Access Compliance Report

Public Rights-of-Way

(Curb Ramps)

Intersection ID: 8940	Main Street: LUDWIG_DR	Cross Street: PENTLOW_PL	Location:	N
ADA ID: 03D30FE20F49	Ramp Type: BlendTrans2	Initial Pass/Fail: Fail	Overall Compliance: No	Severity Score: 12.5
Codes/Mitigation Info/Possible Solution		Field Measurements/Component Compliance

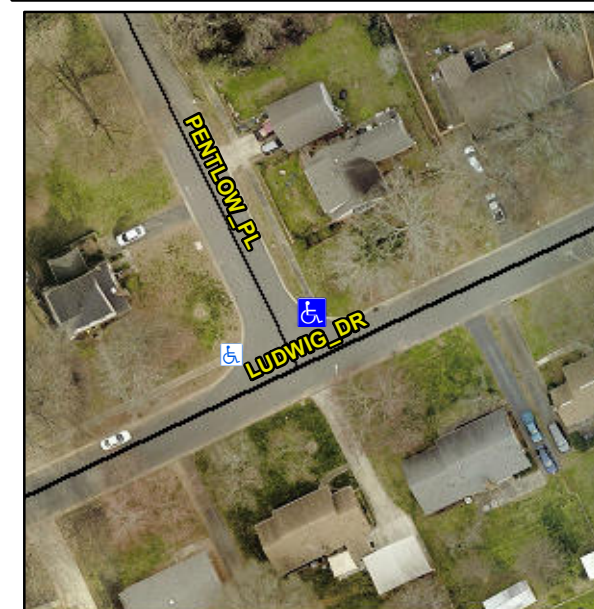
Not Found, R304.5.3

Compliance	Description	Data	Compliance	Description	Data
N/A	Ramp Length (in)	30.0	Yes	BlendTrans Slope (%)	1.1
Yes	Ramp Width (in)	48.0	No	BlendTrans XSlope (%)	5.5
N/A	Flare Type LT	N/A	N/A	Flare Type RT	N/A
N/A	Flare Slope LT (%)	N/A	N/A	Flare Slope RT (%)	N/A
N/A	Flare Traversable LT?	N/A	N/A	Flare Traversable RT?	N/A
N/A	Landing Length (in)	N/A	N/A	DWS Provided?	N/A
N/A	Landing Width (in)	N/A	N/A	DWS Contrast?	N/A
N/A	Landing Slope (%)	N/A	N/A	DWS Length (in)	N/A
N/A	Landing X Slope (%)	N/A	N/A	DWS Full Width?	N/A
N/A	Landing Curb? (Y/N)	N/A	N/A	DWS Offset (in)	N/A
N/A	Shared Landing?	N/A			
N/A	Gutter Ponding?	N/A	N/A	Gutter Slope (%)	N/A
N/A	Gutter Lip Ht (in)	1.0	N/A	Gutter X Slope (%)	N/A
N/A	Painted X Walk1?	No	N/A	Painted X Walk2?	N/A
	X Walk 1 Direction	To SW		X Walk 2 Direction	N/A
	X Walk 1 Width (in)	N/A		X Walk 2 Width (in)	N/A
	X Walk 1 Slope (%)	1.3		X Walk 2 Slope (%)	N/A
	X Walk 1 X Slope (%)	6.0		X Walk 2 X Slope (%)	N/A

N/A	Ramp inside XWalk1?	N/A	N/A	Ramp inside XWalk2?	N/A
	Road Slope (%)	6.0		Clear Space?	N/A
	Road X Slope (%)	1.3	N/A	Clear Space to XWalk (in)	N/A
N/A	Any Obstructions?	N/A	N/A	Storm Grate/Utility Hazard?	N/A
	Obstruction Type			Storm Grate/Utility Type	
		N/A			N/A
			Yes	Surface Condition? (G/P)	Good
			No	Curb Slope (%)	25.8

Remove & Replace Curb Ramp With Two New Directional Ramps or Equivalent.
